SJRWMD Responses to Peer Review Comments Regarding the Draft MFLs for Sylvan Lake, Seminole County, Florida

11/29/2023

Figure 2. From MFL Report Appendix B.

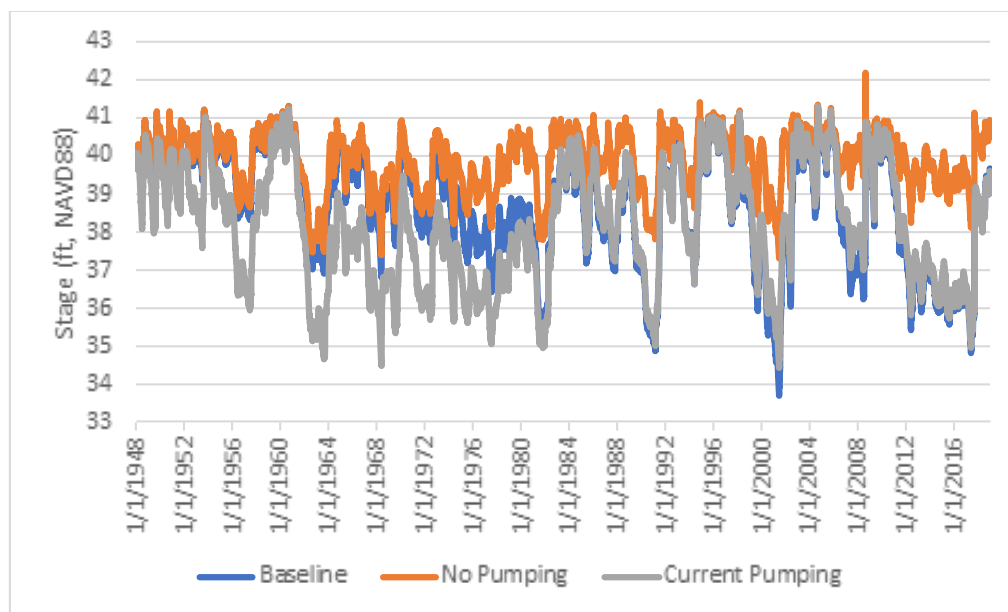
Figures 2 and 3 depict the estimated historical regional pumping and the associated estimated lake level hydrographs based on different pumping scenarios, respectively.

Figure 3. From MFL Report Appendix B

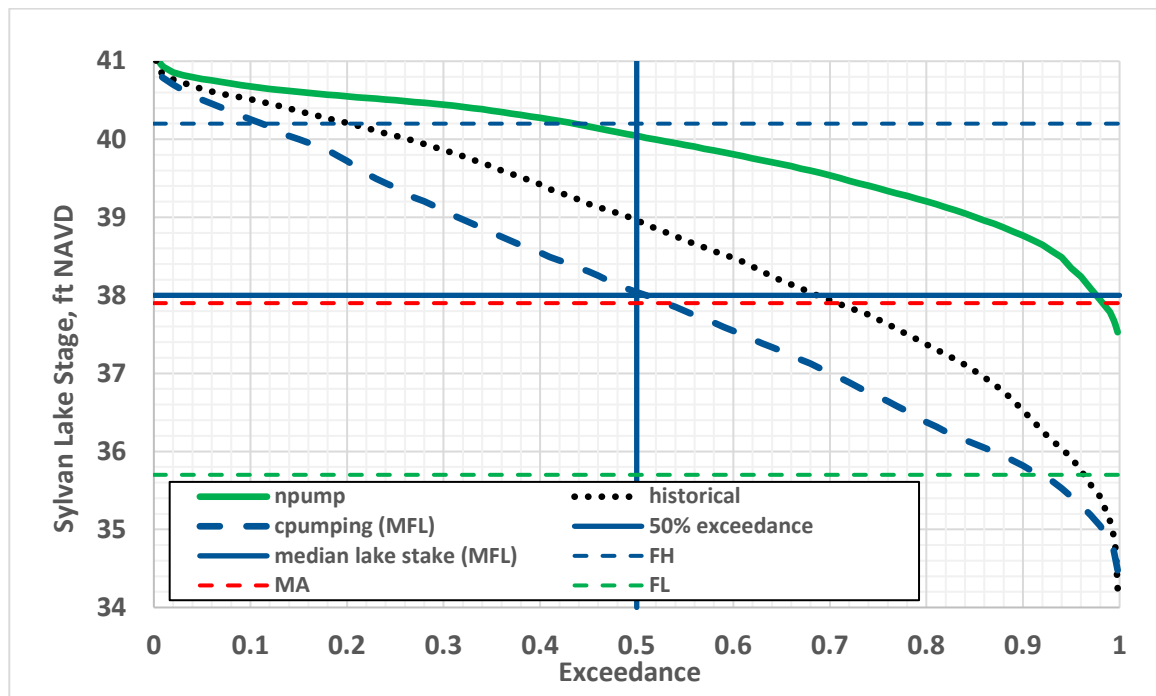
The word baseline shows up only in Appendix B, Figure B-17, and is synonymous with the historical record in this MFL. Other Districts view baseline as the historical record with the effects of withdrawals due to pumping removed, or like the no-pumping condition. This distinction is important because it establishes a reference condition as one that includes effects due to pumping.

We no longer use “Baseline” term to prevent confusion among the districts and public. What was shown in Figure B-17 (now Figure B-19) was a typo. We updated the figure by replacing “Baseline” with “Historical”.

Figure 4. No-pumping, historical (baseline), and current (MFLs) condition exceedance curves for Sylvan Lake, Seminole County, Florida

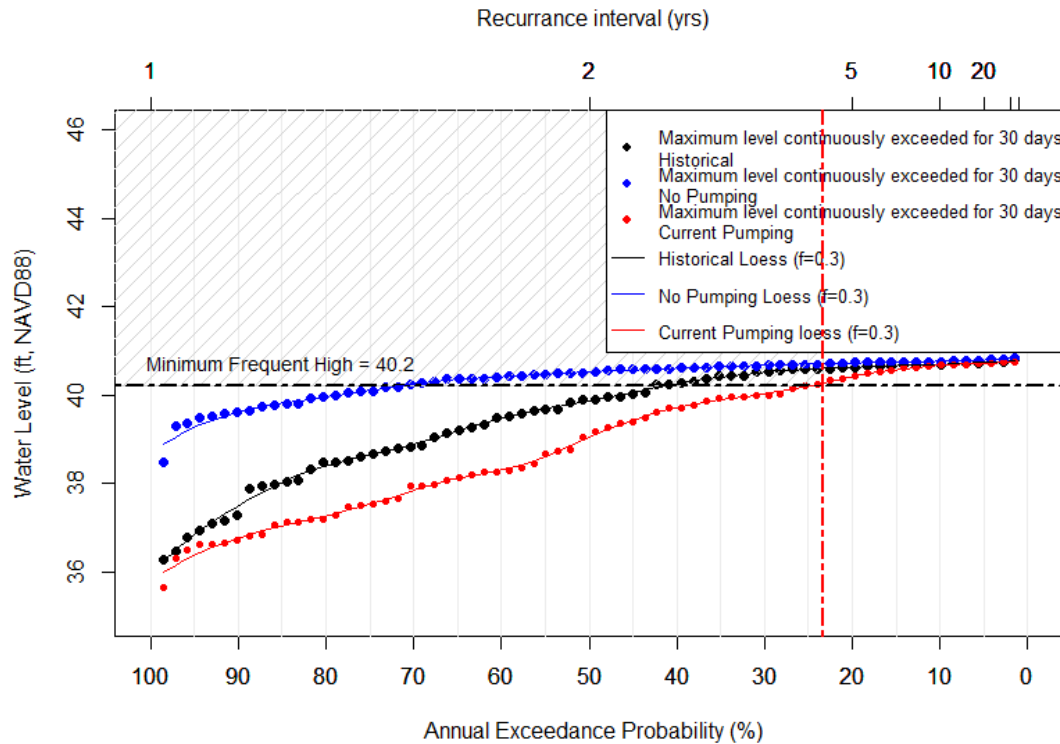
Figure 4 depicts stage duration curves for the pumping scenario data series. Note that the control structure limits the impact of withdrawals at the high stage end, and that impacts increase at progressively lower lake stage.

At the median lake stage, about half of the impact occurs from the no-pumping to the historical pumping scenarios and the other half from historical to the current pumping (and the MFL) scenarios. At progressively lower lake stage, greater impact is attributed to historical withdrawals. The total estimated impact of pumping on lake level is about 2 ft at the median and 3.5 ft at minimum lake levels.

- i. For clarity, consider adding information presented in Figures 4 – 6 to appropriate figures in the Sylvan Lake MFL Report and or appendices.

We agree. The Weibull plots now include the MFLs elevation and return interval, the current-pumping condition data, current-pumping return interval and no-pumping data.

Figure 5. Minimum Frequent High (FH) Weibull plot

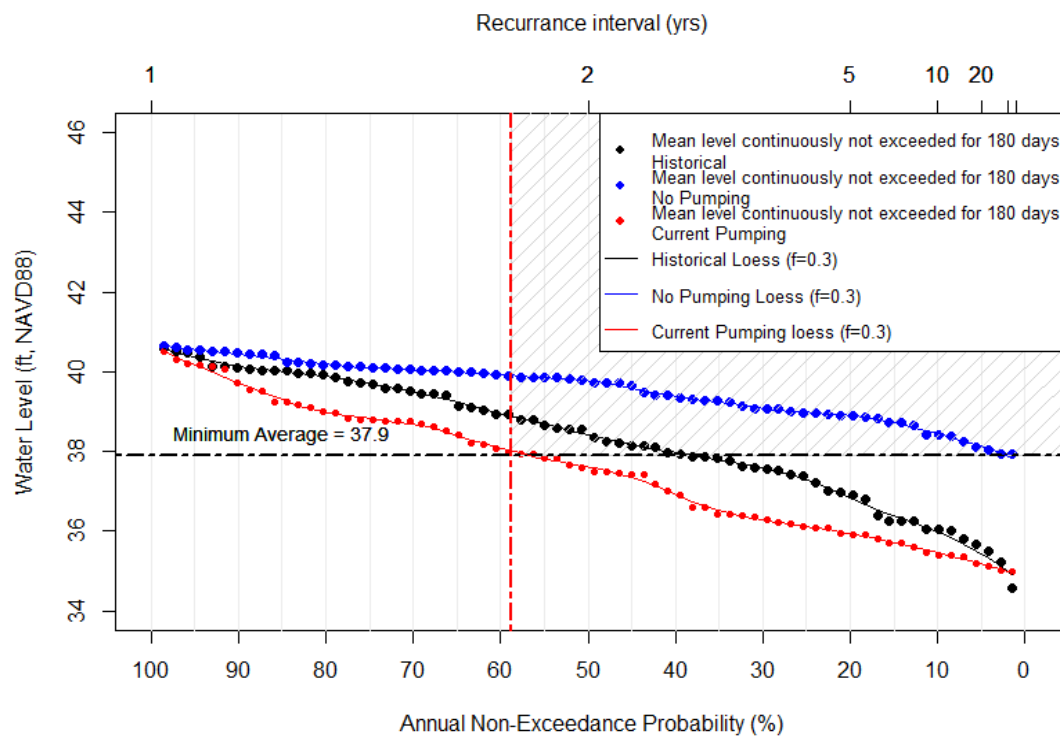
Figures 5 through 7 depict the Weibull plots associated with the three MFL metrics (FH, MA, and FL) and for the different pumping scenarios and the MFL scenario (i.e., current pumping). The Weibull plots provide information similar to the FDCs presented in Figure 4 but also support the District's approach of setting MFLs based on an allowable shift in the frequency of the key events (i.e., FH, MA, and FL).
